Access Compliance Report

Public Rights-of-Way

Intersection ID: 46817	Main Street: ARBOR_VISTA_DR	Cross Street: HOLM_OAK_PL	Location: SE
ADA ID: BC3EDDFF6D29	Ramp Type: Perp	Initial Pass/Fail: Fail	Overall Compliance: No
Severity Score: 12.5			
Codes/Mitigation Info/Possible Solution		Field Measurements/Component Compliance

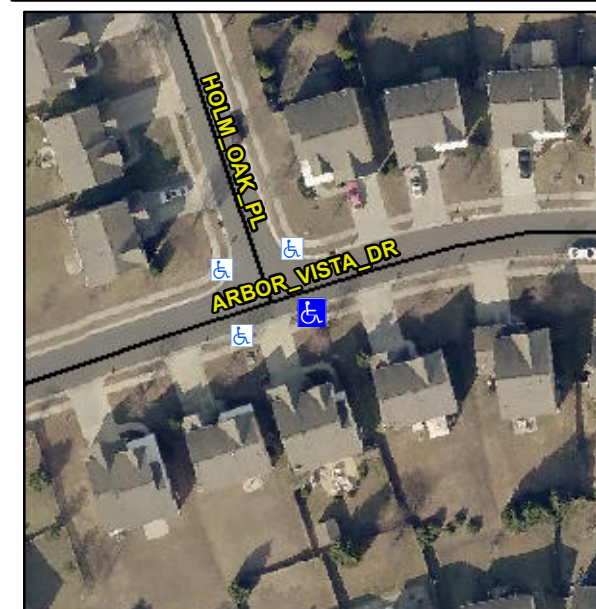
Not Found, R304.2.2

Compliance	Description	Data	Compliance	Description	Data
N/A	Ramp Length (in)	47.0	No	Ramp Slope (%)	9.5
Yes	Ramp Width (in)	51.0	Yes	Ramp XSlope (%)	1.2
N/A	Flare Type LT	N/A	N/A	Flare Type RT	N/A
N/A	Flare Slope LT (%)	N/A	N/A	Flare Slope RT (%)	N/A
N/A	Flare Traversable LT?	N/A	N/A	Flare Traversable RT?	N/A
N/A	Landing Length (in)	N/A	N/A	DWS Provided?	N/A
N/A	Landing Width (in)	N/A	N/A	DWS Contrast?	N/A
N/A	Landing Slope (%)	N/A	N/A	DWS Length (in)	N/A
N/A	Landing X Slope (%)	N/A	N/A	DWS Full Width?	N/A
N/A	Landing Curb? (Y/N)	N/A	N/A	DWS Offset (in)	N/A
N/A	Shared Landing?	N/A			
N/A	Gutter Ponding?	N/A	N/A	Gutter Slope (%)	N/A
N/A	Gutter Lip Ht (in)	N/A	N/A	Gutter X Slope (%)	N/A
N/A	Painted X Walk1?	No	N/A	Painted X Walk2?	N/A
	X Walk 1 Direction	To N		X Walk 2 Direction	N/A
N/A	X Walk 1 Width (in)	N/A	N/A	X Walk 2 Width (in)	N/A
	X Walk 1 Slope (%)	2.7		X Walk 2 Slope (%)	N/A
	X Walk 1 X Slope (%)	2.0		X Walk 2 X Slope (%)	N/A

Remove & Replace Entire Ramp.
